MILITARY SPECIFICATION

PROJECTILE, 155MM, HE, RA, M549A1
FORWARD (M37 EXTRUDED) PROPELLANT GRAIN FOR

This amendment forms a part of Military Specification MIL-P-63202, dated 13 September 1983 and is approved for use by the US Army Armament, Munitions and Chemical Command and is available for use by all departments and agencies of the Department of Defense.

FIGURE 1

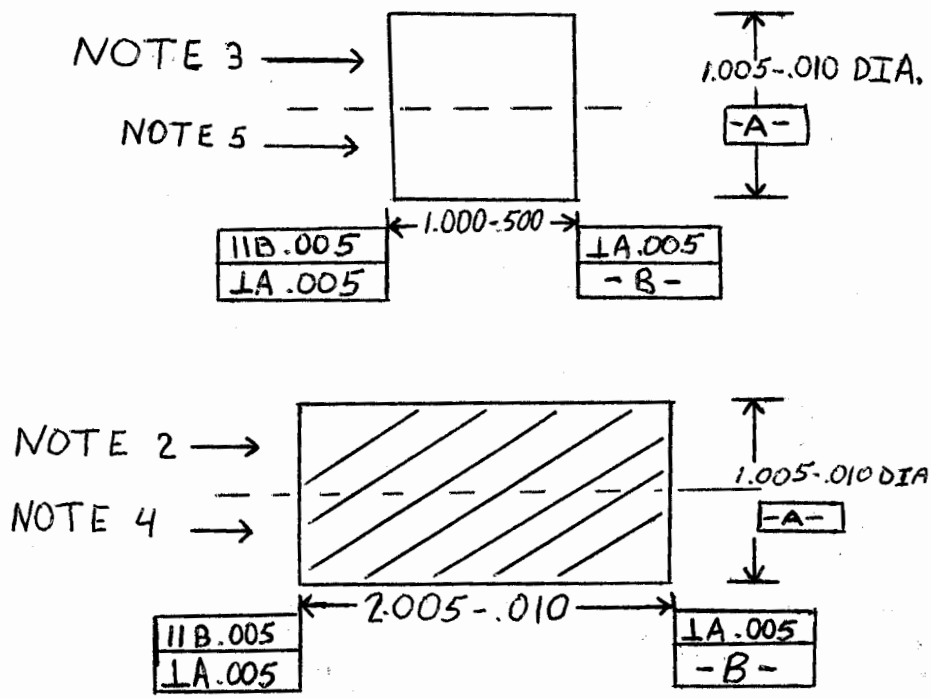
4.5.5: Add the following:

"4.5.5.1 Physical properties - alternate test method. Each specimen and specimen support shall conform to the requirements of Figure 1. The specimen shall be conditioned at the required temperature plus or minus 5°F for three hours, minimum. The specimen shall be removed from the conditioning box and inserted between the fixture posts with steel cylinders the same diameter as the specimen placed above and below the specimen forming one continuous concentric cylinder. The specimen shall be tested using a cross head speed of 2 inches per minute. The total time elapsed from removing the specimen from the conditioning box to the completion of each test shall be 1 ± 1/2 minute. All compression tests shall be conducted in a room that is maintained at 75°F ± 5°F."
